**Before the Expert Panel appointed
under the Fast-track Approvals Act 2024**

In the Matter of an application for approvals by
Matakanui Gold Limited to establish,
operate, rehabilitate and ultimately
close an open pit and underground
gold mining operation known as the
Bendigo-Ophir Gold Project

**Statement of Evidence of
Jens Haaye Rekker on behalf of
Matakanui Gold Limited in response to
Section 53 Feedback
Water**

Dated: 17 April 2026

Figure 1: Topographic profile across axis of Shepherds Creek gorge at SC-01 (satellite image and DEM profile)

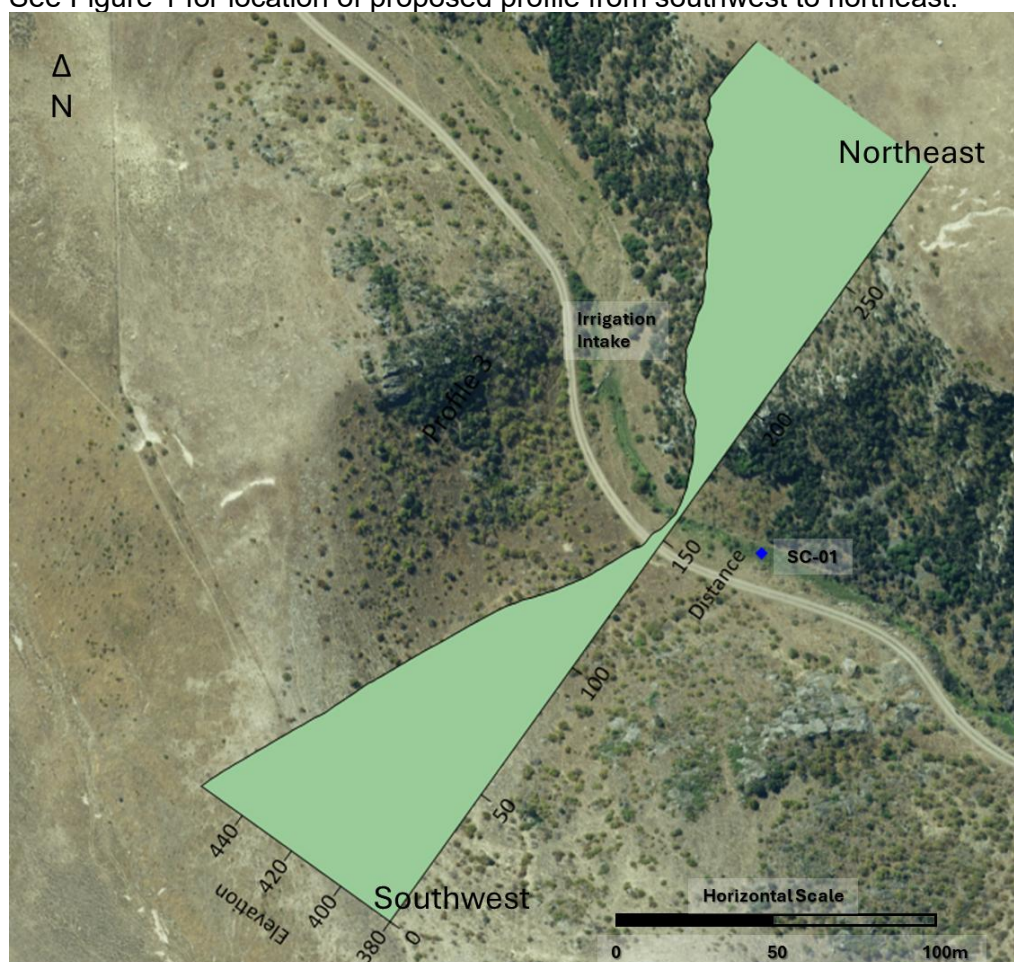
At the 25 February 2026 workshop between Matakanui Gold and Otago Regional Council, the question of installing a fence of drill holes across the gap between schist bluffs at the SC-01 surface water monitoring site was discussed. In essence, the drilling would penetrate unconsolidated alluvium and potentially also consolidated weathered schist, which are the two potential materials for allowing subsurface flow of groundwater through the gap and onwards to the lower Shepherds Creek catchment. Groundwater flow through the gap would bypass the SC-01 monitoring site, and a compliance point. The SC-01 monitoring includes continuous flow measurement in high flow and low flow flumes and sampling of surface water. Both sets of monitoring parameters would be bypassed and potentially be unaccounted should there be appreciable underflow through the gap. See Figure 1 for location of proposed profile from southwest to northeast.

Figure 2: Two-dimensional profile of land surface across axis of Shepherds Creek gorge at SC-01

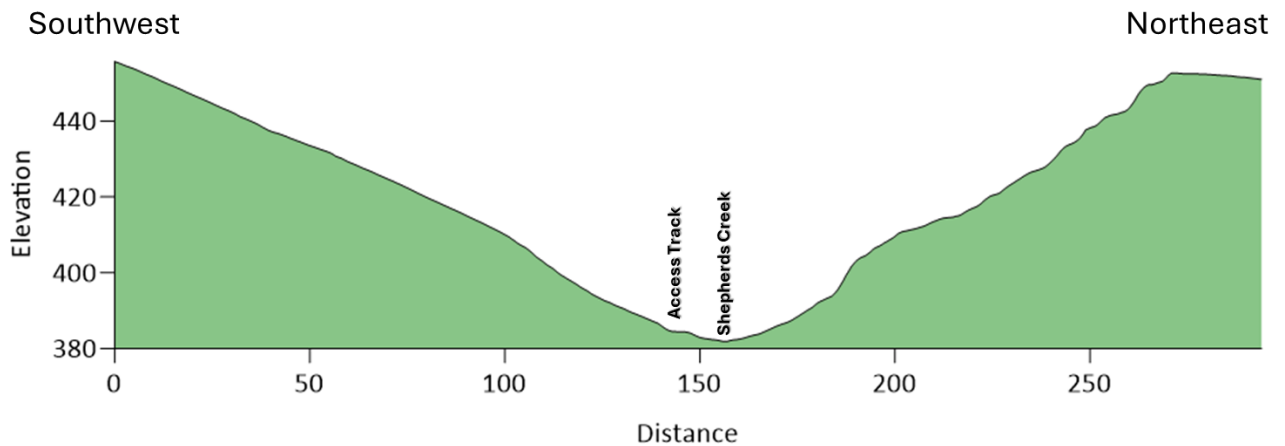
Figure 2 illustrates the profile line as a topographic cross-section of the land surface taken from the merged DEM surface for the area. The base of the gorge (or gully) lies at an elevation of 382.0

metres AMSL. The access track lies at an elevation of 384.1 metres AMSL. The gorge sides suggest a talus slop on both flanks below schist outcrop bluffs at the steepest part of the slope.

Figure 3: Approximate geological cross-section of Shepherds Creek gorge at SC-01

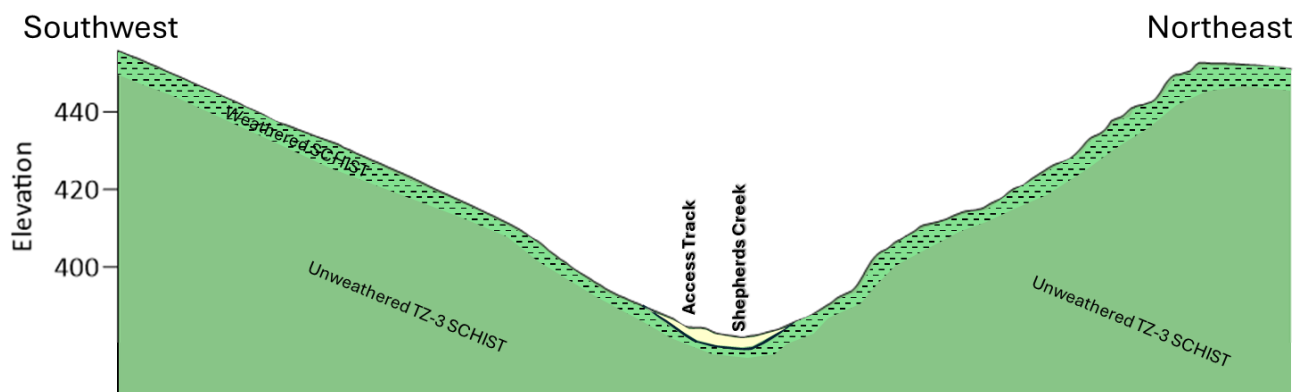
Approximation of the likely disposition of alluvium and weathered schist is illustrated in Figure 3. The cross-section is based on upstream and downstream test pits of the valley floor, the closest of which lies 310 metres upstream.

Figure 4: Representative cross-section through Shepherds Creek gorge showing drill holes d1 – d5

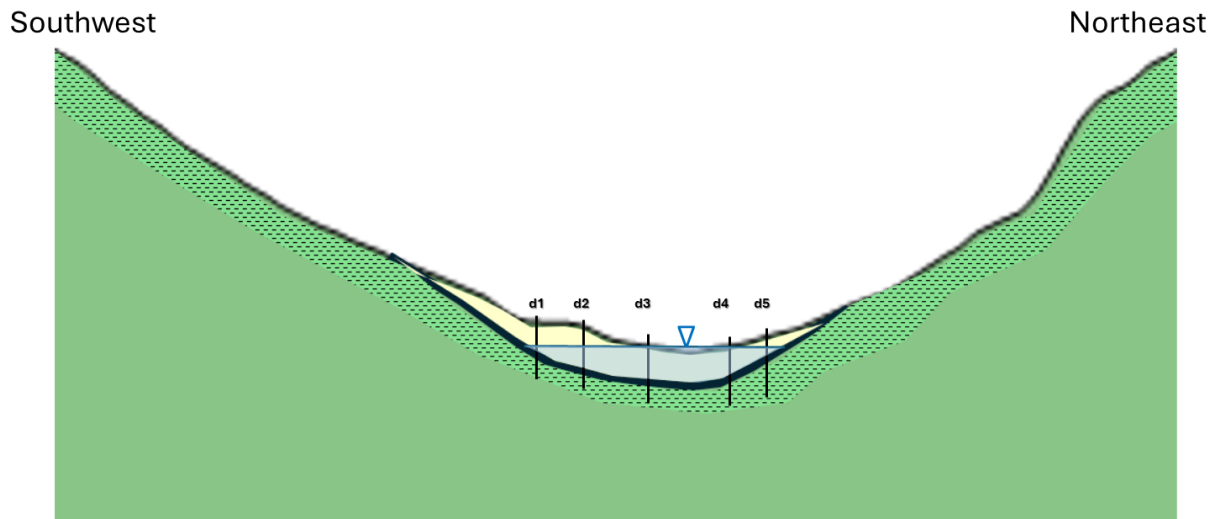
Figure 4 is a representative cross-section through the gorge floor and alluvium illustrating the probable placement of five drill holes to characterise the subsurface, including the potential for groundwater bypass of SC-01. A geotechnical drilling rig would be employed to characterise subsurface conditions as far as possible. Nested piezometers would be designed and placed on the basis of drilling investigations within alluvium and weathered schist for characterisation of the groundwater level profile and any vertical gradients.

The piezometers would also be available for the undertaking of slug tests and potentially a pumping test to characterise hydraulic conductivity. In the long-term the piezometers would be available for the taking of water samples to delineate the composition of any bypass flow. Ultimately, investigations to characterise subsurface seepage would have the ability to quantify any underflow rates and the mass load of defined potential contaminants.

109. The memorandum to ORC in response outlined the installation of at least five drill holes across the gap. The first roles of installed water bores would be to characterise the subsurface hydrogeology, alluvium / weathered schist permeability, saturation levels and pressures, and hydraulic conductivity to assess whether under-seepage was feasible and if so at what rate of seepage.

Figure 11: Trends in monthly nitrate-N at Lindis Peak and Ardgour Road daily mean measured flow rate

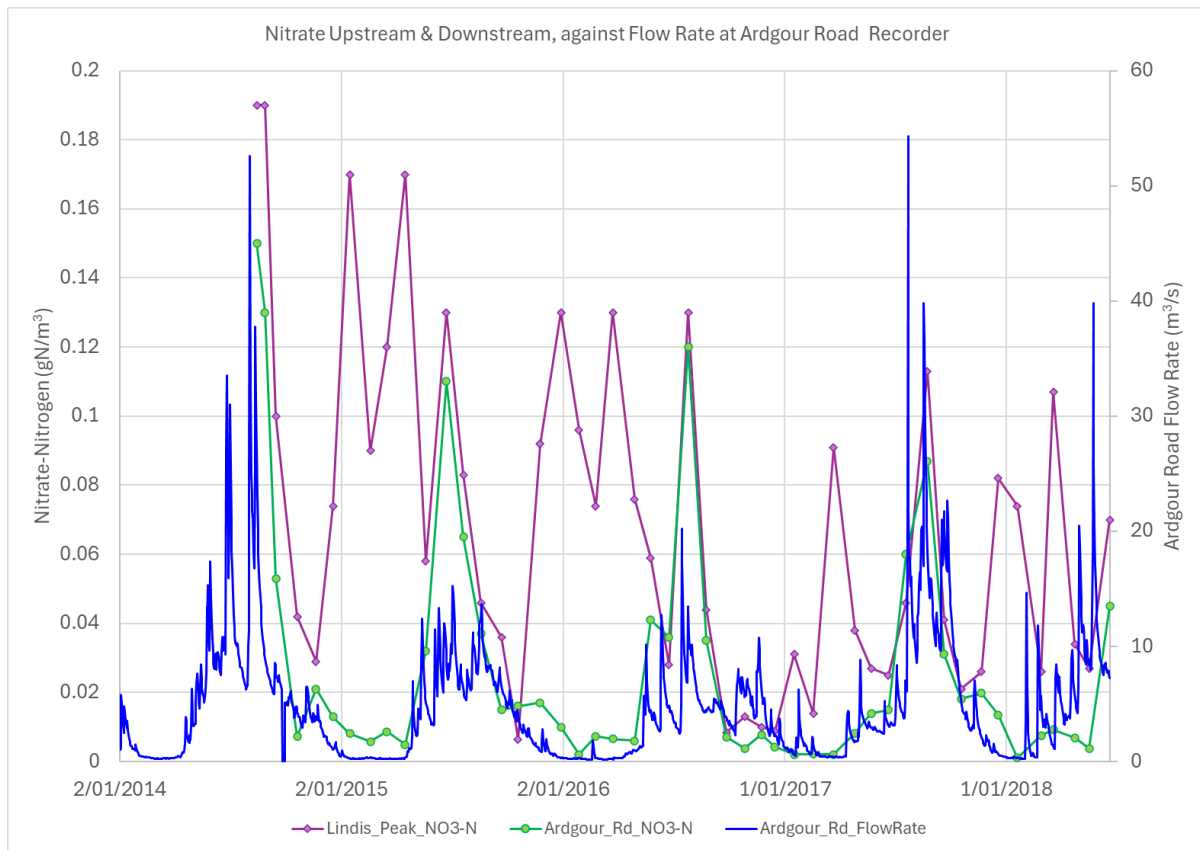
Figure 11 reveals nitrate nitrogen concentrations at Ardour Road following the trend of flow rate, while the nitrate nitrogen concentration at Lindis Peak was markedly more volatile. Figure 12 reveals a strong pattern of dependence between flow rate and nitrate nitrogen concentration at Ardour Road. It is inferred, based on studies in comparable braided river bed catchments, that nitrate accumulates in upstream alluvium and is flushed into surface water through to the river water column by high flows. Low flows are period of declining nitrate nitrogen concentration and depletion of the upgradient nitrate reservoir.
